Access Compliance Report

Public Rights-of-Way

Intersection ID: 28344	Main Street: BELLHAVEN_WALK_CT	Cross Street: BRIDGEHAMPTON_CLUB_DR	Location: SW
ADA ID: 95833FE1894E	Ramp Type: Perp	Initial Pass/Fail: Fail	Overall Compliance: No
Severity Score: 21.25			
Codes/Mitigation Info/Possible Solution		Field Measurements/Component Compliance

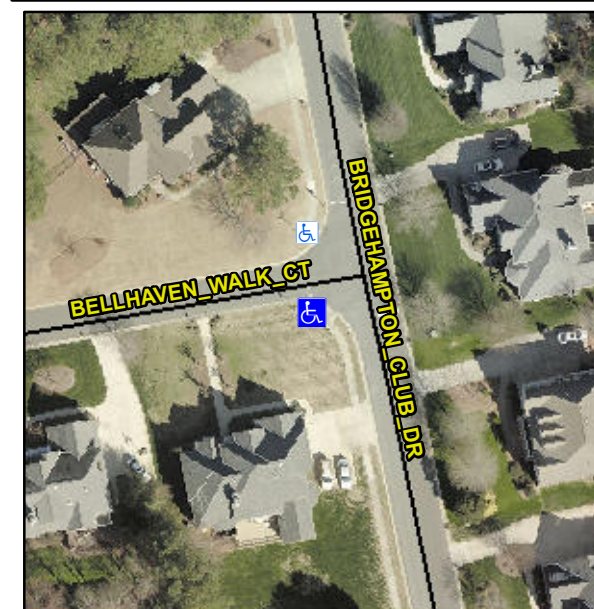
Not Found, R304.5.1, R304.2.2

Compliance	Description	Data	Compliance	Description	Data
N/A	Ramp Length (in)	49.0	No	Ramp Slope (%)	9.5
No	Ramp Width (in)	41.0	Yes	Ramp XSlope (%)	0.1
N/A	Flare Type LT	N/A	N/A	Flare Type RT	N/A
N/A	Flare Slope LT (%)	N/A	N/A	Flare Slope RT (%)	N/A
N/A	Flare Traversable LT?	N/A	N/A	Flare Traversable RT?	N/A
N/A	Landing Length (in)	N/A	N/A	DWS Provided?	N/A
N/A	Landing Width (in)	N/A	N/A	DWS Contrast?	N/A
N/A	Landing Slope (%)	N/A	N/A	DWS Length (in)	N/A
N/A	Landing X Slope (%)	N/A	N/A	DWS Full Width?	N/A
N/A	Landing Curb? (Y/N)	N/A	N/A	DWS Offset (in)	N/A
N/A	Shared Landing?	N/A			
N/A	Gutter Ponding?	N/A	N/A	Gutter Slope (%)	N/A
N/A	Gutter Lip Ht (in)	N/A	N/A	Gutter X Slope (%)	N/A
N/A	Painted X Walk1?	No	N/A	Painted X Walk2?	N/A
	X Walk 1 Direction	To N		X Walk 2 Direction	N/A
N/A	X Walk 1 Width (in)	N/A	N/A	X Walk 2 Width (in)	N/A
	X Walk 1 Slope (%)	0.5		X Walk 2 Slope (%)	N/A
	X Walk 1 X Slope (%)	2.1		X Walk 2 X Slope (%)	N/A

Remove & Replace Entire Ramp.
